PCN-20190105 TE0706-02 to TE0706-03 Hardware Revision Change

Company	Trenz Electronic GmbH
PCN Number	PCN-20190105
Title	TE0706-02 to TE0706-03 Hardware Revision Change
Subject	Trenz Electronic TE0706 Hardware Change
Issue Date	2019-04-11

This change affects all variations of TE0706 carrier of revision: TE0706-02

#8 VBAT connector fitted

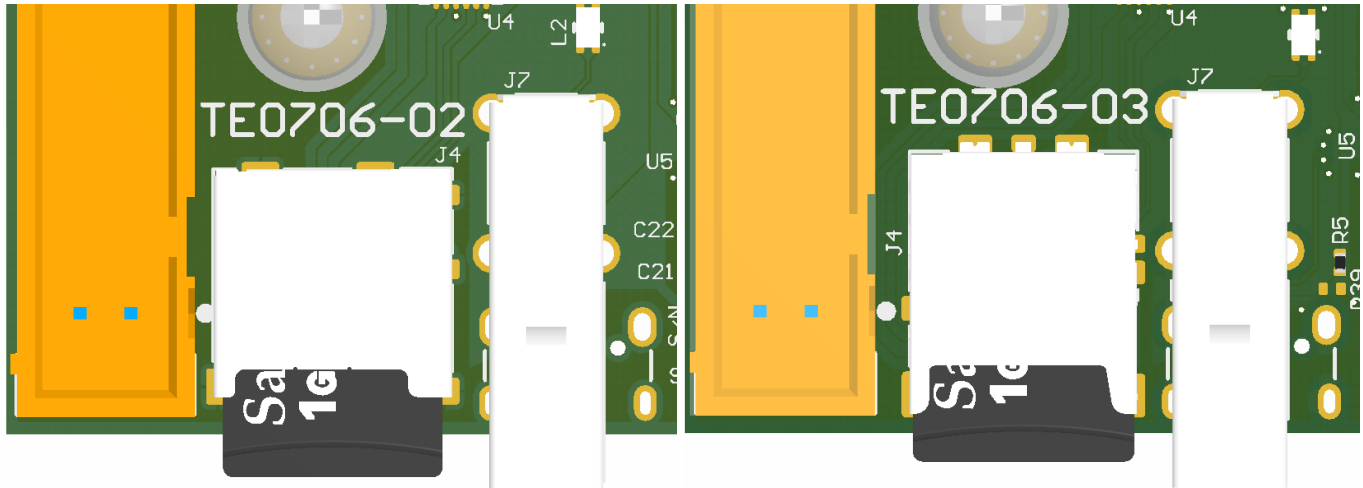
Type: Assembly change

Reason: Change from THT to SMD

Impact: Connector assembled
